Project: **OAHS Multi-Use Room Building**
Project No. 2-2022-02-22-01
 Orcutt Academy High School
 610 Pinal Ave, Orcutt, CA 93455

BID ADDENDUM 08

ADDENDUM NO. B

Project: Orcutt Union School District
Orcutt Academy High School
Multi-Use Room Building
19six No. 20179.01
DSA App. No.: 03-121912 File No.: N/A
Bid No.:

SHEET NO.
G-101
DATE: MAY 20, 2022

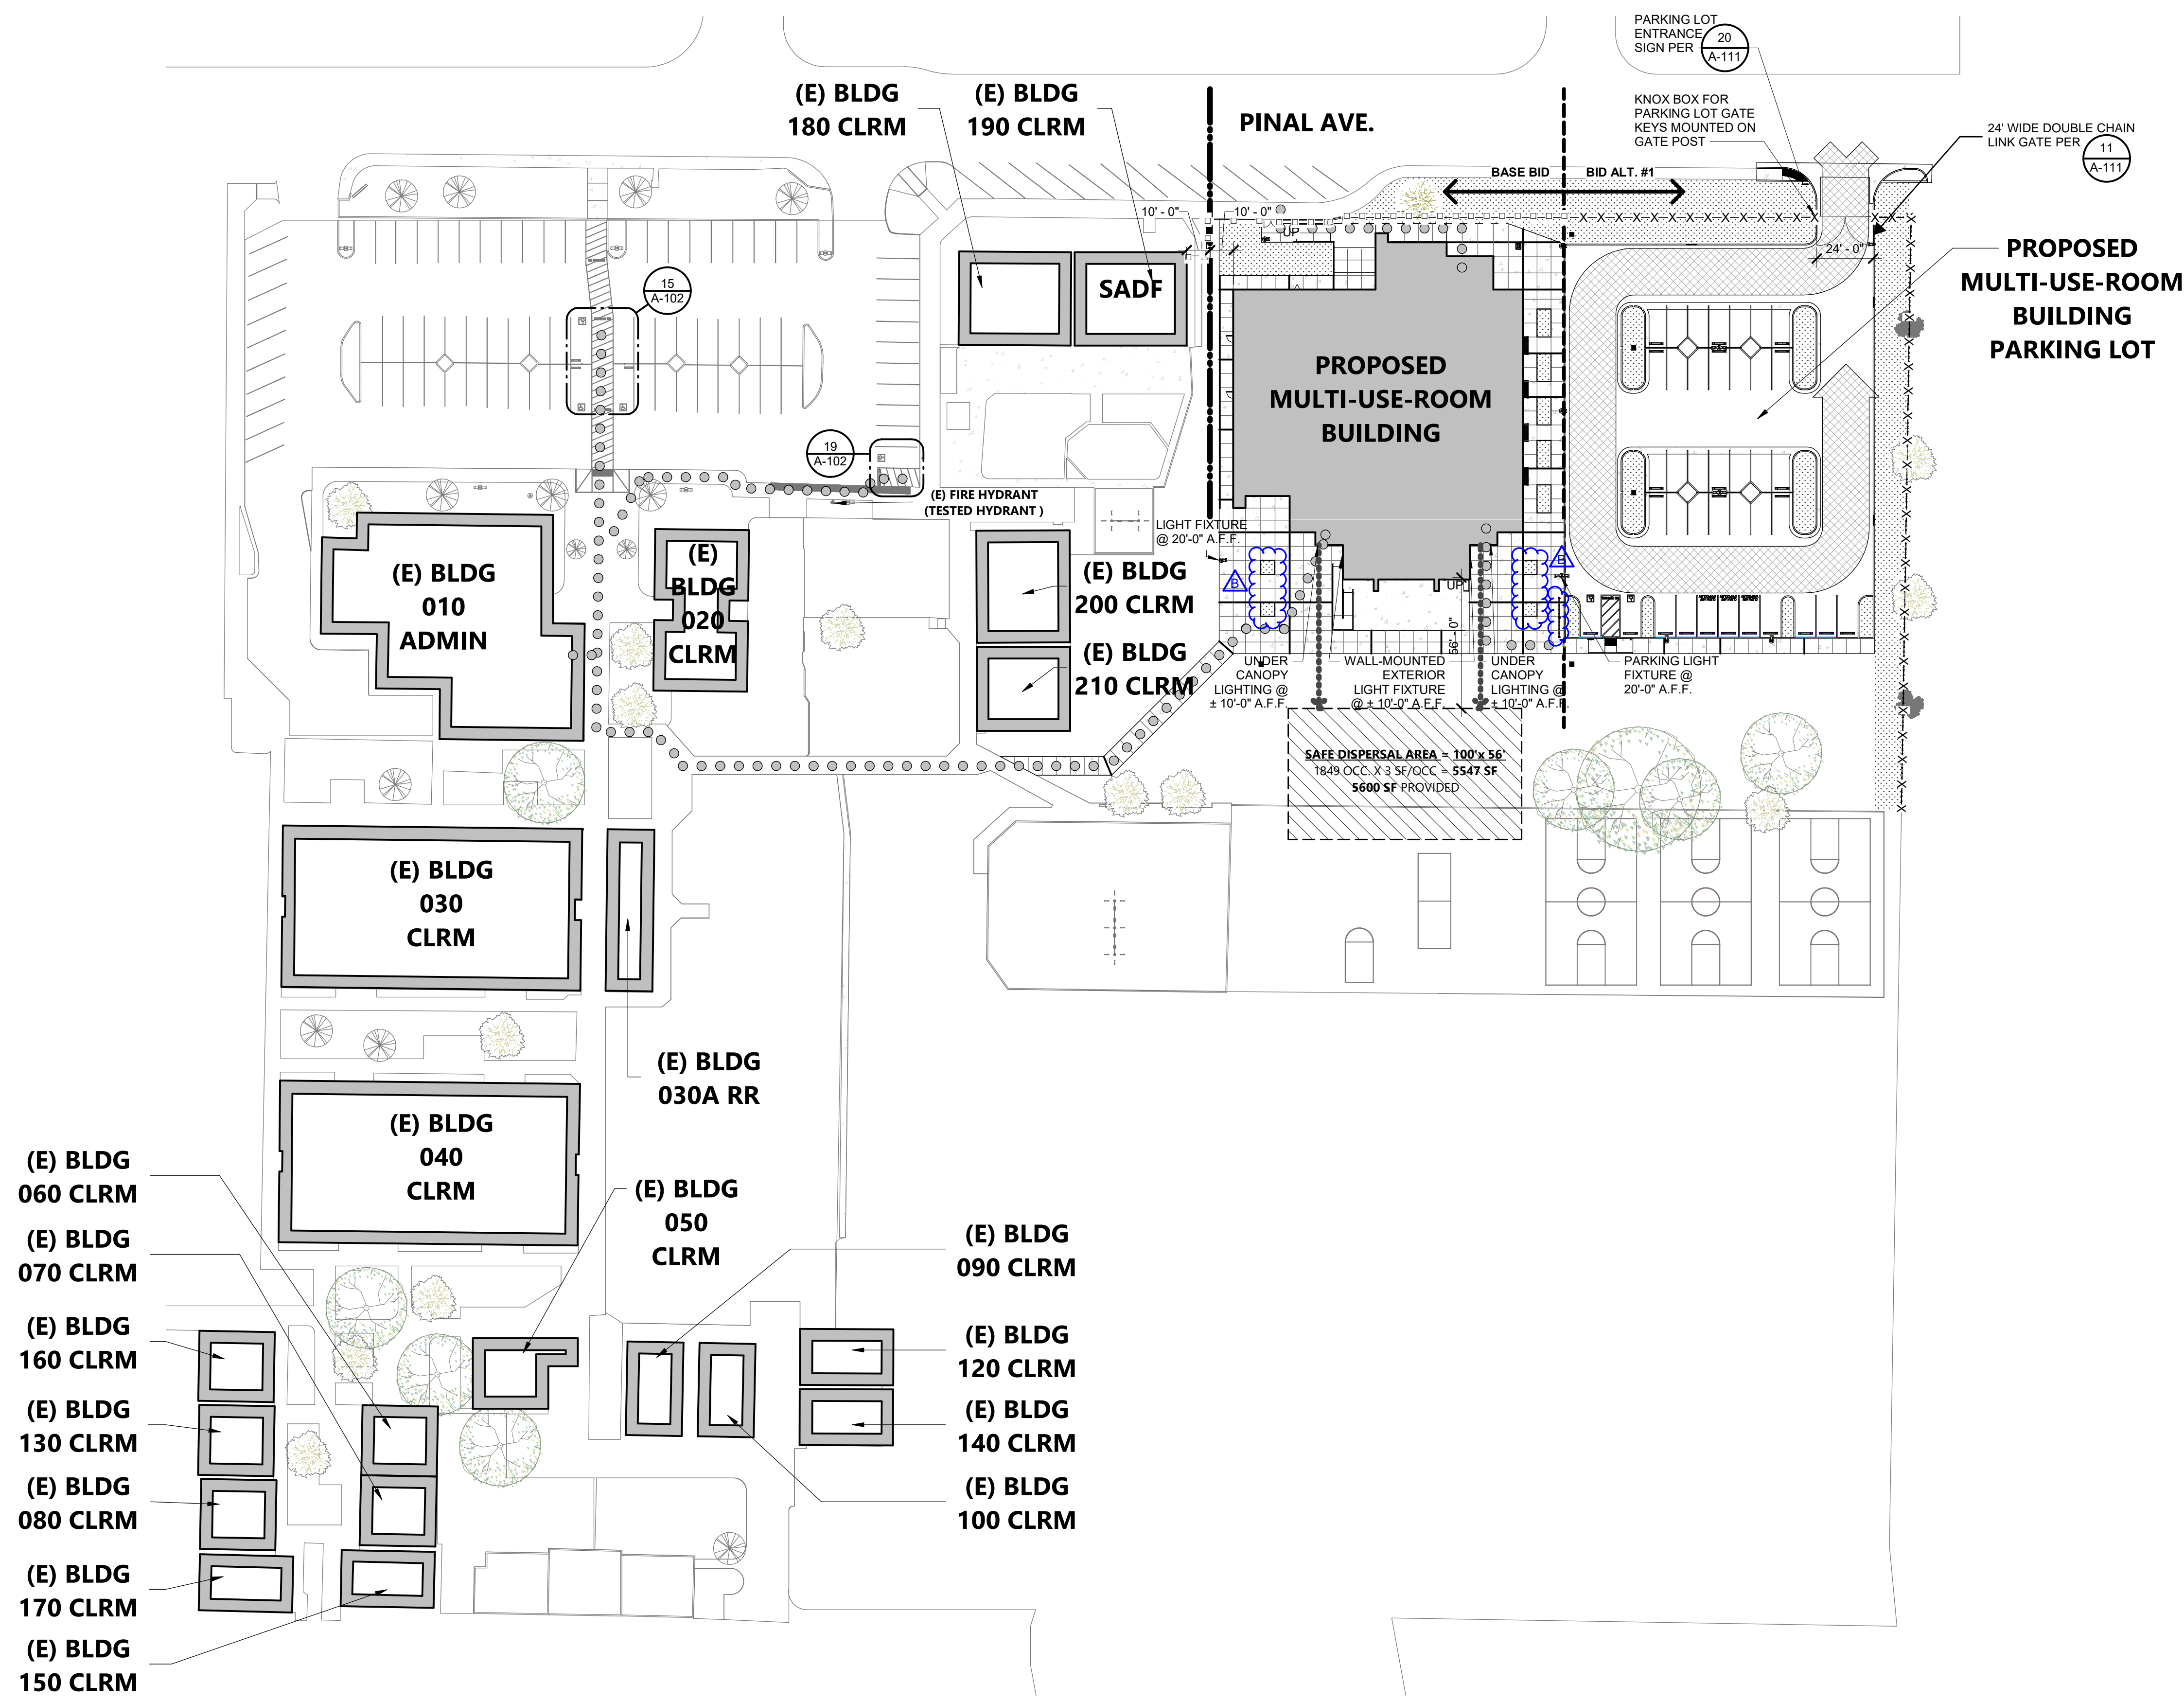
- Item #1:** **Landscaping.** Revise landscaping and irrigation plans. See revised sheets L-101, L-201, G-101 and A-101.
- Item #2:** **Future EV Charging Stations.** Revise number of future EV charging stations from 2 to 4. Add location of additional future EV charger. See revised sheets A-101 and E-101.
- Item #3:** **Bike Rack.** Add one additional 7-capacity bike rack. Provide total capacity for 14 bikes. Add product information for bike rack on detail 25 of sheet A-111. See revised sheets G-101, A-101 and A-111.

SHEET NO.
G-101
DATE: APRIL 5, 2022

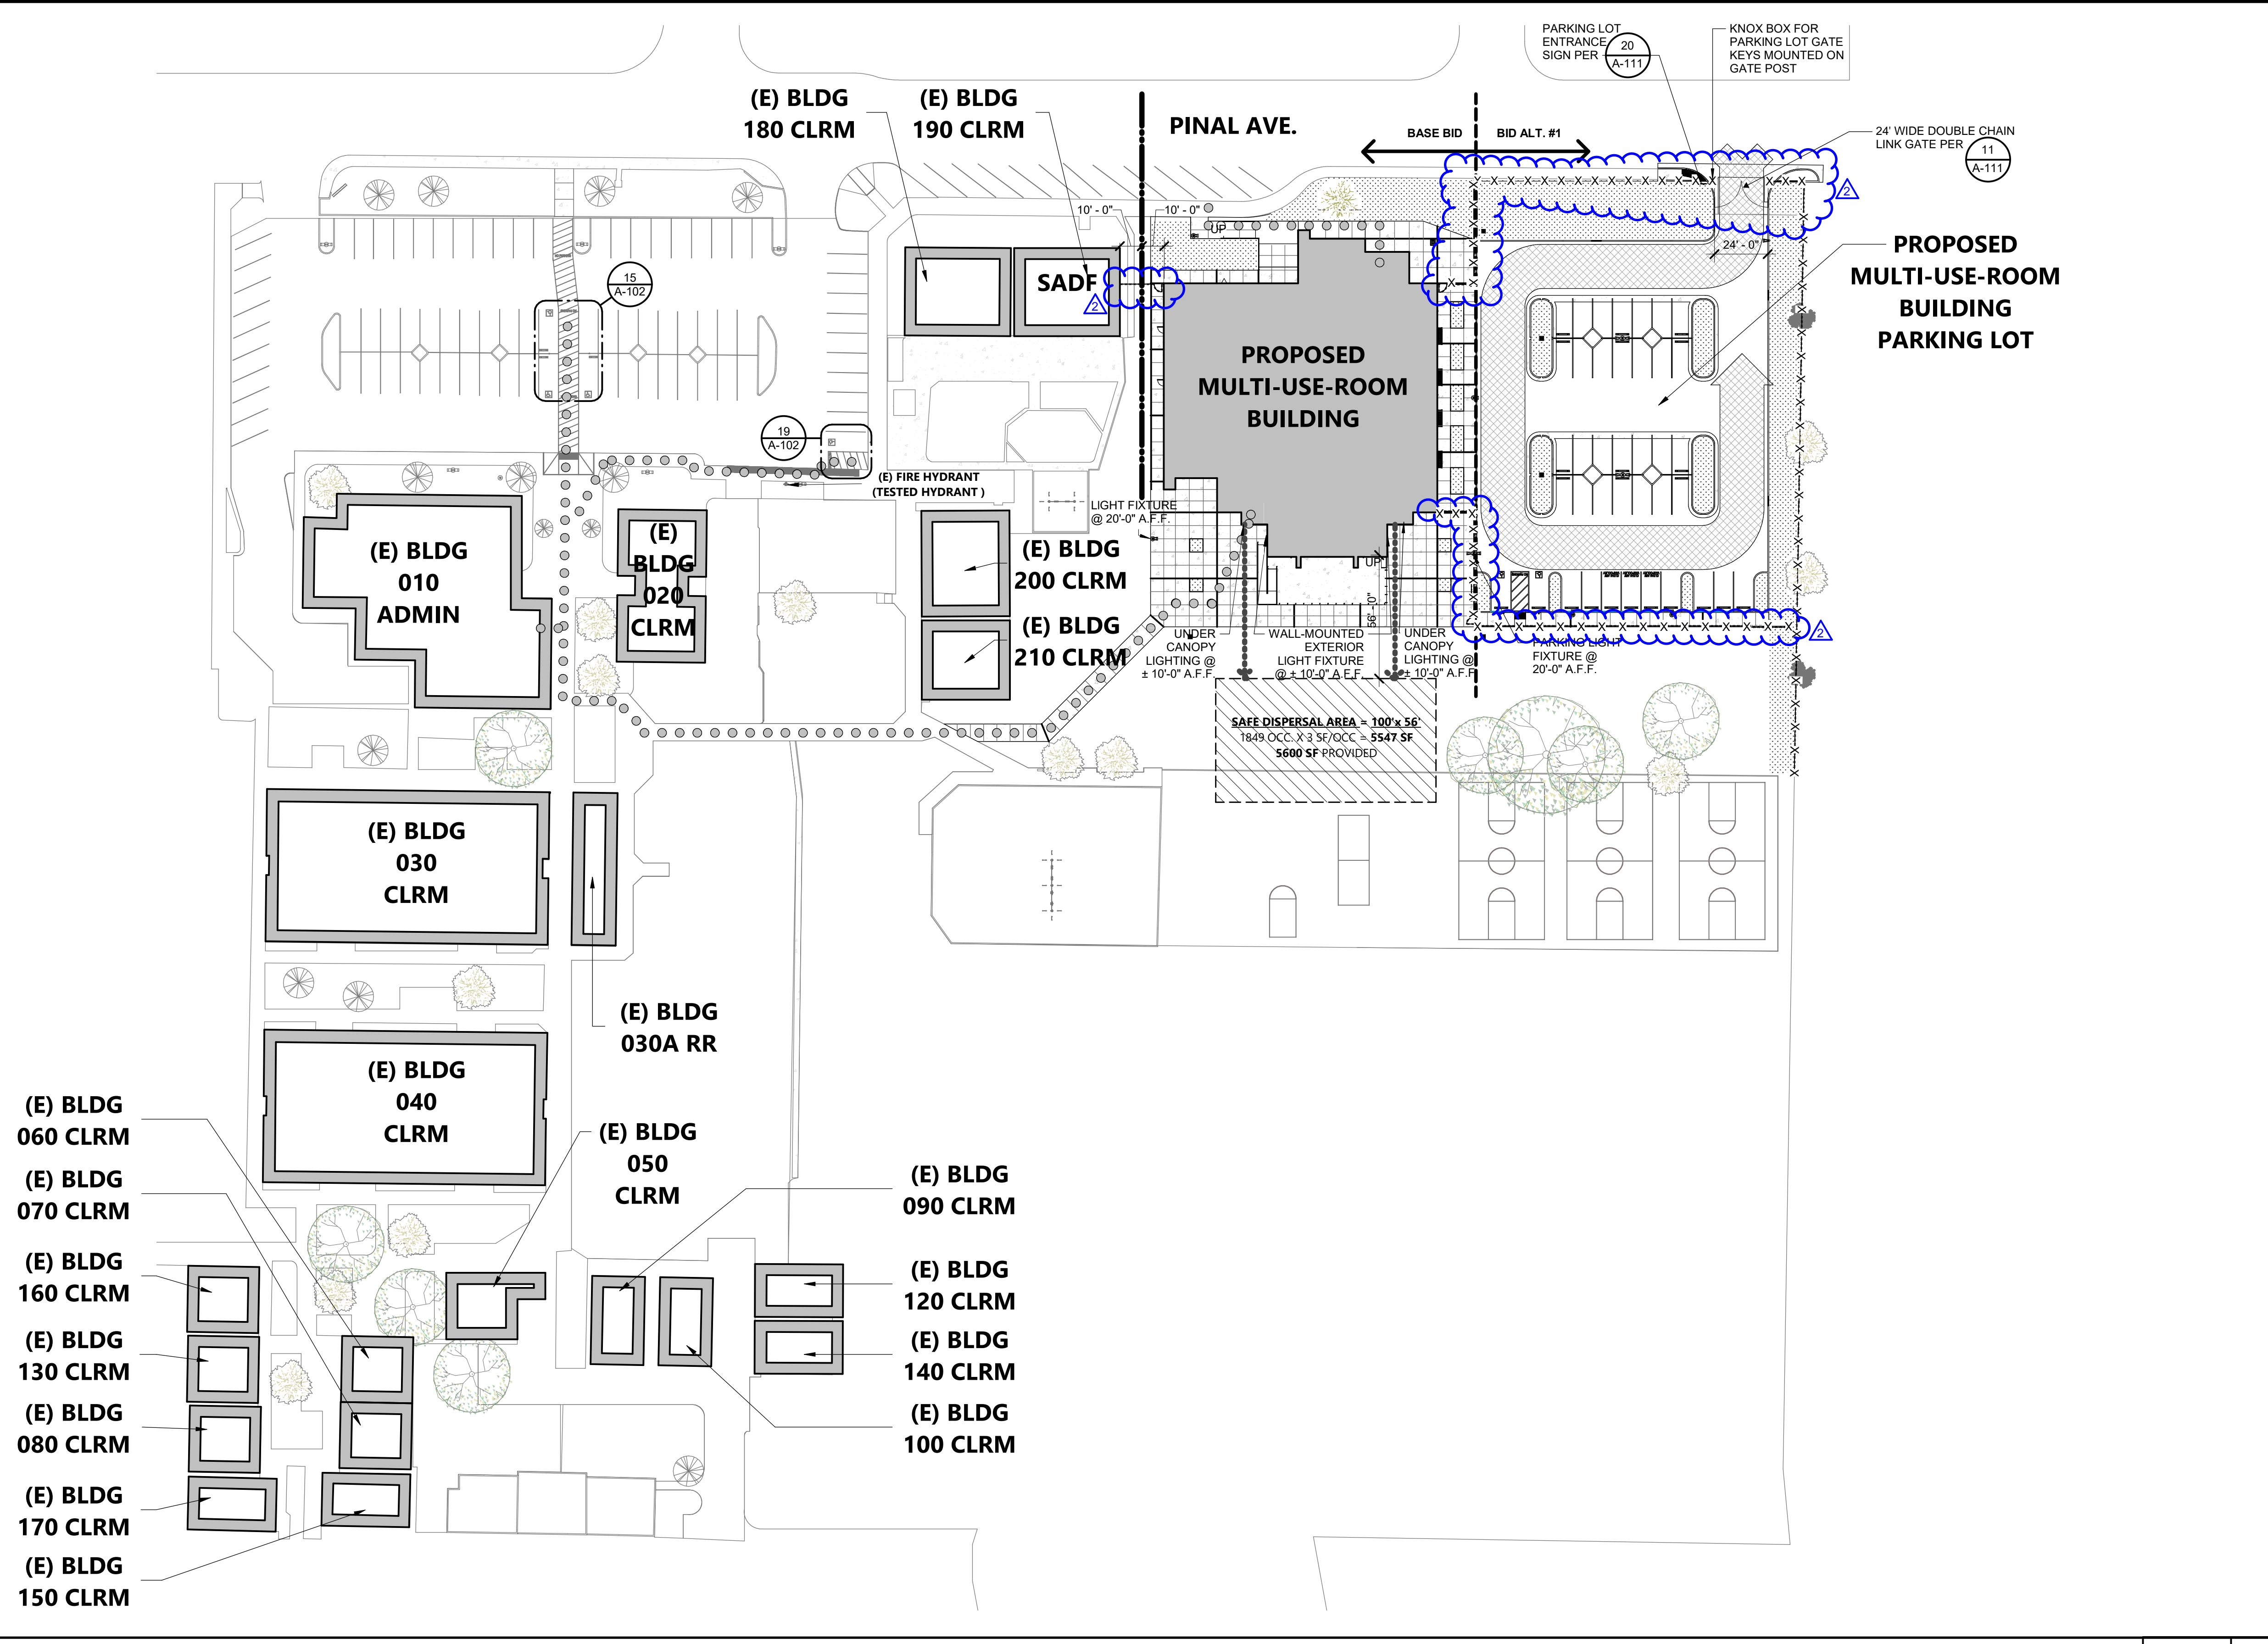
Item #2: **Fencing.** Revise fencing. See revised sheets G-101 and A-101 and A-102.

SHEET NO.
A-202
DATE: APRIL 5, 2022

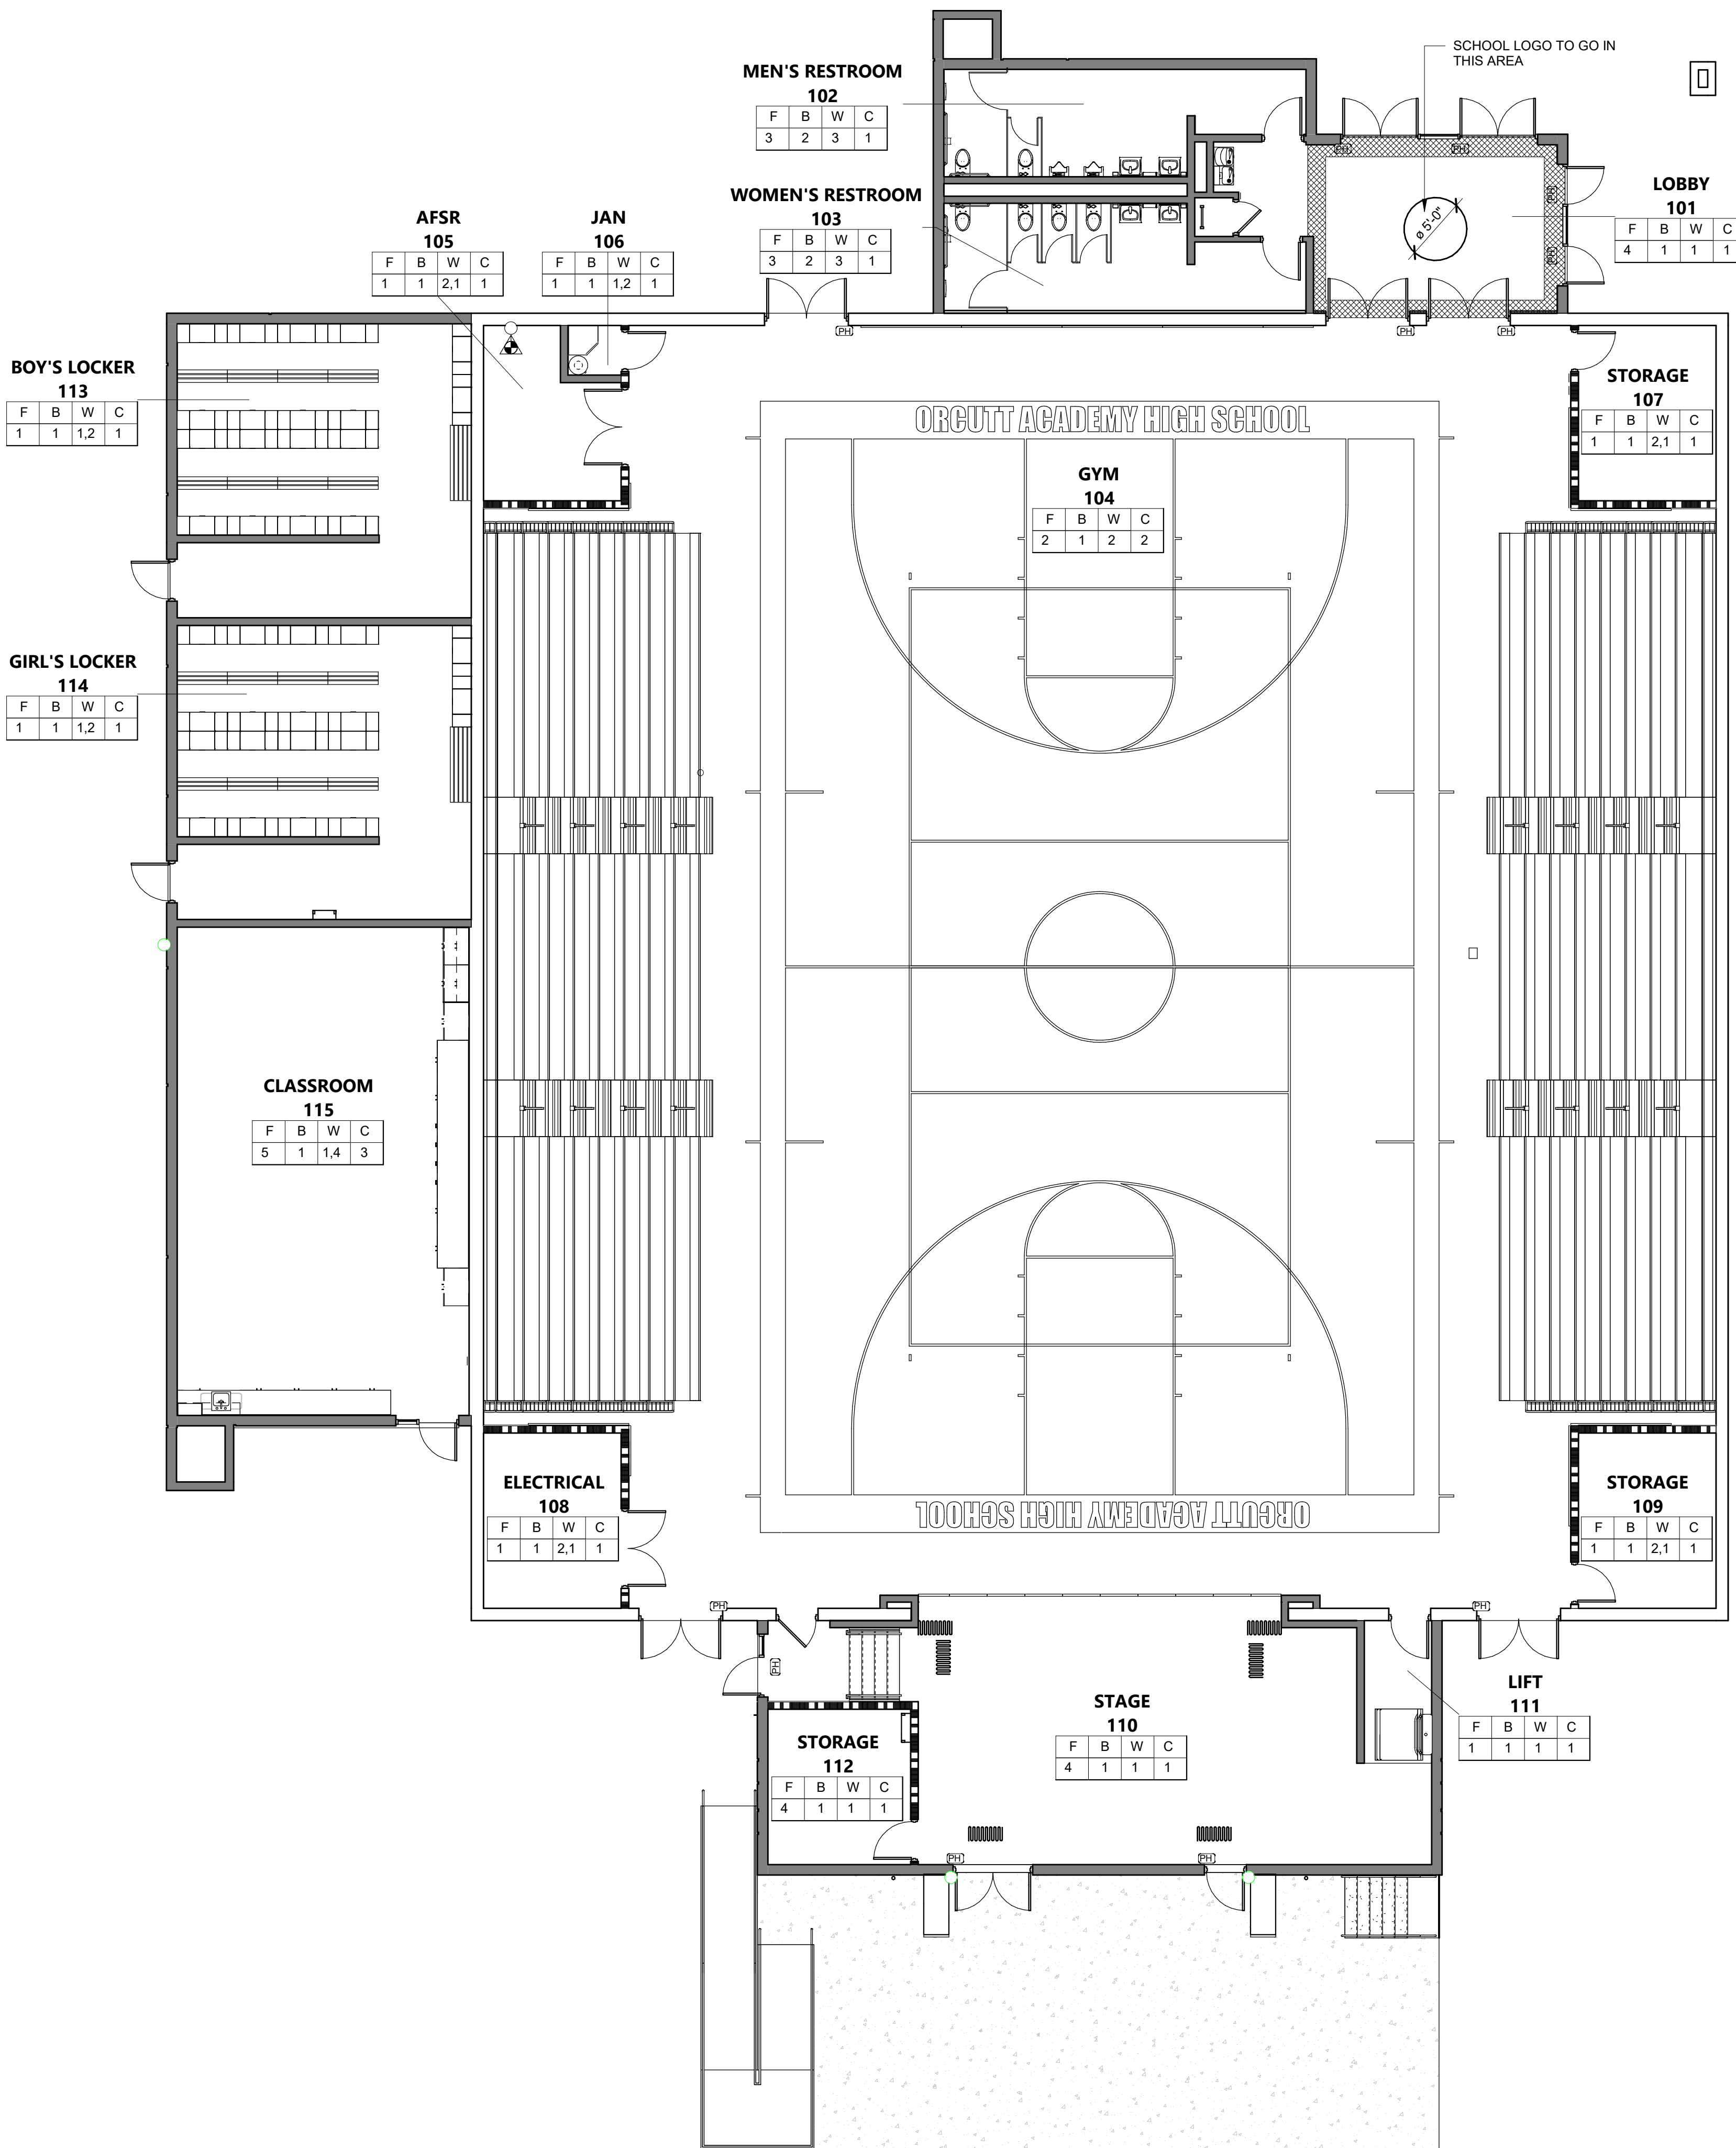
Item #3: **Volleyball Post Floor Sleeves.** Revise locations of volleyball floor sleeves. See revised sheets A-201 and A-202.
